Access Compliance Report

Public Rights-of-Way

(Curb Ramps)

Intersection ID: 50942	Main Street: CEDAR_WALK_LN	Cross Street: DUNAVERTY_PL	Location: SE
ADA ID: F54A8138FFDB	Ramp Type: PerpDiag	Initial Pass/Fail: Fail	Overall Compliance: No
Severity Score: 35			
Codes/Mitigation Info/Possible Solution		Field Measurements/Component Compliance

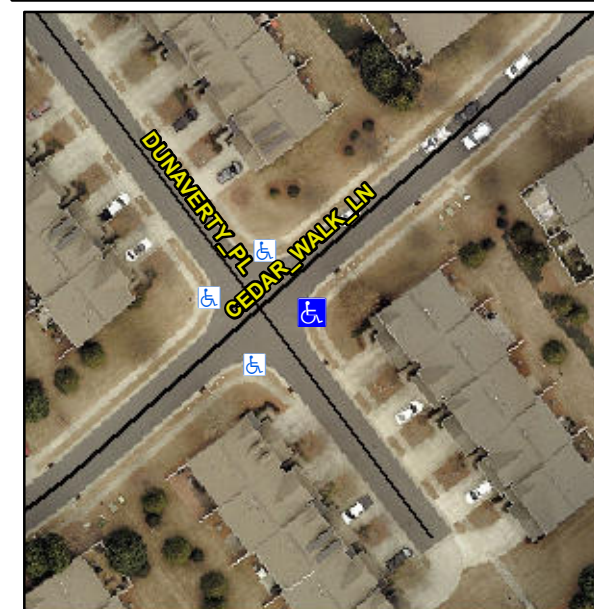
Not Found, R304.5.1, R304.2.2, R304.5.3

Compliance	Description	Data	Compliance	Description	Data
N/A	Ramp Length (in)	47.0	No	Ramp Slope (%)	12.2
No	Ramp Width (in)	47.0	No	Ramp XSlope (%)	4.2
N/A	Flare Type LT	N/A	N/A	Flare Type RT	N/A
N/A	Flare Slope LT (%)	N/A	N/A	Flare Slope RT (%)	N/A
N/A	Flare Traversable LT?	N/A	N/A	Flare Traversable RT?	N/A
N/A	Landing Length (in)	N/A	N/A	DWS Provided?	N/A
N/A	Landing Width (in)	N/A	N/A	DWS Contrast?	N/A
N/A	Landing Slope (%)	N/A	N/A	DWS Length (in)	N/A
N/A	Landing X Slope (%)	N/A	N/A	DWS Full Width?	N/A
N/A	Landing Curb? (Y/N)	N/A	N/A	DWS Offset (in)	N/A
N/A	Shared Landing?	N/A			
N/A	Gutter Ponding?	N/A	N/A	Gutter Slope (%)	N/A
N/A	Gutter Lip Ht (in)	N/A	N/A	Gutter X Slope (%)	N/A
N/A	Painted X Walk1?	No	N/A	Painted X Walk2?	No
	X Walk 1 Direction	To NW		X Walk 2 Direction	To SW
N/A	X Walk 1 Width (in)	N/A	N/A	X Walk 2 Width (in)	N/A
	X Walk 1 Slope (%)	1.6		X Walk 2 Slope (%)	0.6
	X Walk 1 X Slope (%)	1.9		X Walk 2 X Slope (%)	0.3

Remove & Replace Curb Ramp With Two New Directional Ramps or Equivalent.
